Revision Number	Date	Drawn	Issued For	Details of Issue / Revision
P02	19/05/23		Response to RFI	
P01	29/04/22		Issued For Planning

Project Details:
 Dalguise
 Monkstown

Drawing Title:
 Proposed GA Plans - Block C

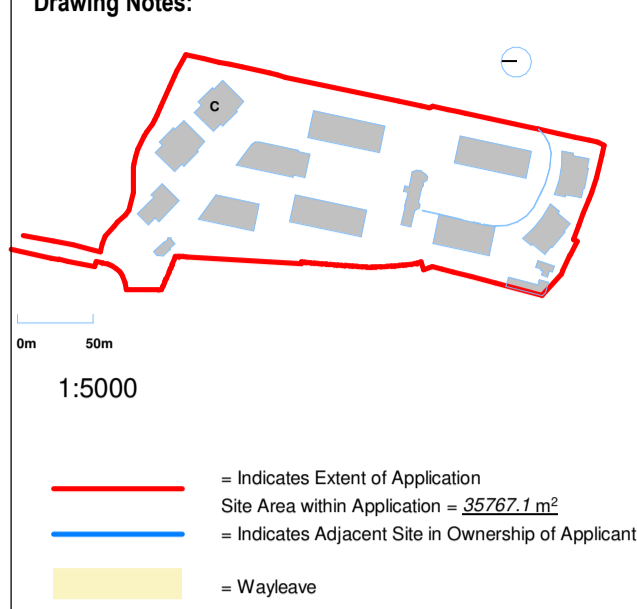
- REVISIONS**
- C1. Tonal change at penthouse level.
 - C2. Brick indent detail added to facade
 - S3. New external amenity space added ground floor between Block B+C.
 - B3. Access route to new amenity space added at ground level (lwr)
 - B4. Private Balcony added to Apartments B_00_01 and C_00_01 (Refer to HQA for areas)
